INFORMATION REQUEST

APPLICATION NO: RL/66/2024
PROPERTY ADDRESS: 680-688 & 690-702 CHAMBERS FLAT ROAD AND 691-697, 699-705, 707-713 & 715-721 LOGAN RESERVE ROAD, LOGAN RESERVE QLD 4133
PROPERTY DESCRIPTION: LOT 12 RP 106853, LOT 13 RP 106853, LOT 29 RP 106853, LOT 28 RP 106853, LOT 27 RP 106853, LOT 26 RP 106853
APPLICATION DESCRIPTION: RECONFIGURING A LOT (6 LOTS INTO 166 LOTS)

Figure 2: The nominated connection point to the ultimate sewer solution

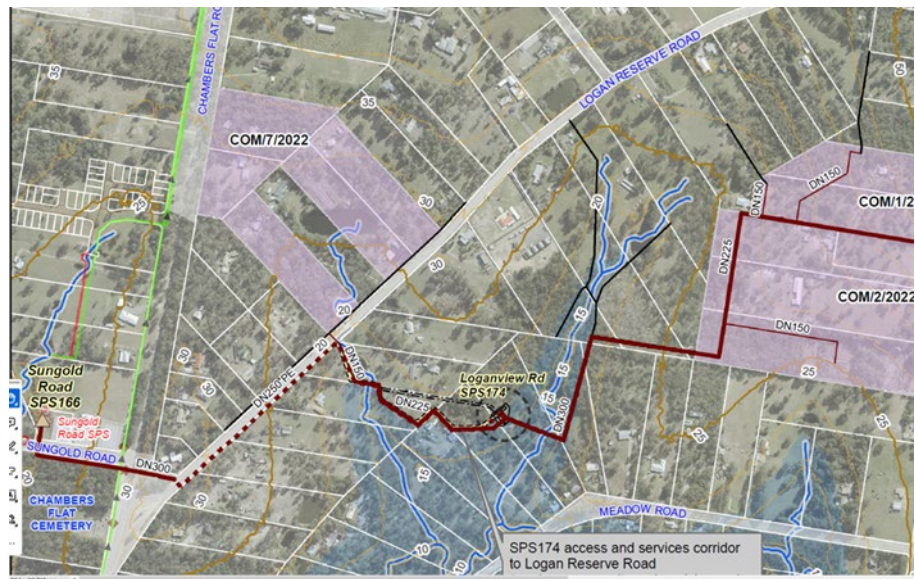
- 8.1. In addition to the above, Amend the Sewer and Water Reticulation Layout Plan to show:
- 8.1.1. All combined easements over sewer main and stormwater main, easements width is to be a minimum of 4 metres as per the Code;
- 8.1.2. The sewer main to be extended to the upstream COM/93/2022 development through proposed Lot 4 or another agreed alternative and allow for the approved operational works sewer design (application no. OW/19/2024/A); and
- 8.1.3. The nominated connection point to the ultimate sewer solution as planned by Council in the ultimate solution shall generally comply with the below *Figure 2* and shall extend from the southwest corner of the site.

Please note that the below Figure is indicative only and is conceptual in nature and does not reflect the outcomes of the aforementioned study.
